BCA ASSESSMENT REPORT

**LAHC – 67-69 Pioneer Road,
28-30 Bramsen Street, Bellambi**

**NSW Land and Housing
Corporation**

Revision: 6

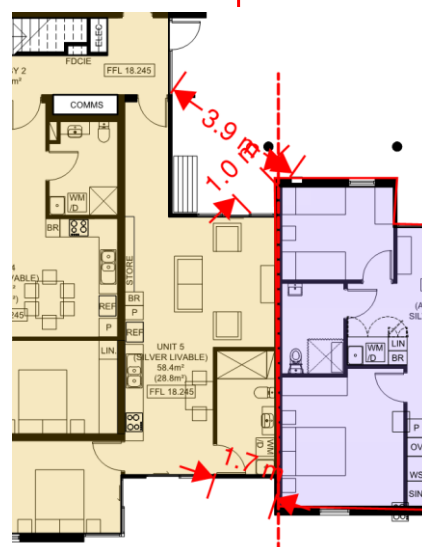
The distance between parts of external walls and any openings within them in different fire compartments separated by a fire wall must be at least that set out in Table C3.3 unless-

- + Those parts of each wall have an FRL of at least 60/60/60; and
- + Any openings protected in accordance with C3.4.

Fire walls achieving a fire rating of 90/90/90 FRL are to be utilised to compartmentalise the building so that the building contains fire compartments are less than 1,000m² as required by BCA Cl. E1.3 & AS2419.1-2005 Table 2.1 which has been specified by the APFS wet Fire to rationalise the number of hydrants required to flow.

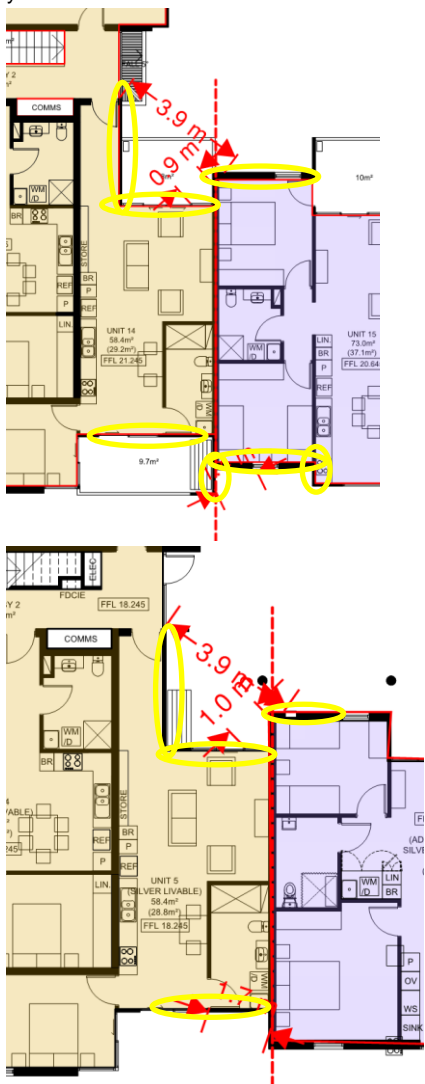
In this regard the fire compartment max compartment size within the building is circa 723m². Once a fire wall is implemented BCA Cl. C3.3 requires assessment of adjoining fire compartments which may require portions of wall (or openings therein) are protected as per BCA Cl. C3.4.

Where exposed, a DTS solution would require the separate fire compartments to be protected with the portions of the external wall (both sides) to achieve 60/60/60 FRL and openings protected as per C3.4 with external drenchers (and fixed in the closed position) and fire dampers achieving -/60/- FRL.

The following portions of external wall are closer than 6m (directly opposite) or closer than 4m (diagonally) which require protection as per BCA Clause C3.3/C3.4:

<p>The below mark-up identifies the portions of external wall /openings exposed; refer to circled yellow areas:</p>  <p>It is understood that a Fire Engineered Performance Solution could assess the protection only of one side and not both sides. In this regard the Fire Engineered Solution would consider upgrading the fire wall and external (on one side only) to 120/120/120 FRL (double DTS) and look to not protect the other side i.e. the blank walls could be specified as 120/120/120 FRL to alleviate protection of the side which may contain window openings.</p>
<p>C3.4 Acceptable methods of protection</p>	<p>Where protection is required, doorways, windows and other openings must be protected as follows:</p> <ul style="list-style-type: none"> + Doorways – <ul style="list-style-type: none"> (a) Internal or external wall-wetting sprinklers as appropriate used with doors that are self-closing or automatic closing; or (b) -/60/30 fire doors that are self-closing or automatic closing. + Windows – <ul style="list-style-type: none"> (a) Internal or external wall-wetting sprinklers as appropriate used with windows that are automatic closing or permanently fixed in the closed position; or (b) -/60/- automatic closing fire shutters. + Other openings – <ul style="list-style-type: none"> (a) Excluding voids – internal or external wall-wetting sprinklers, as appropriate; or (b) Construction having FRL not less than -/60/-. 	<p>Compliance Readily Achievable</p> <p>Refer above.</p>
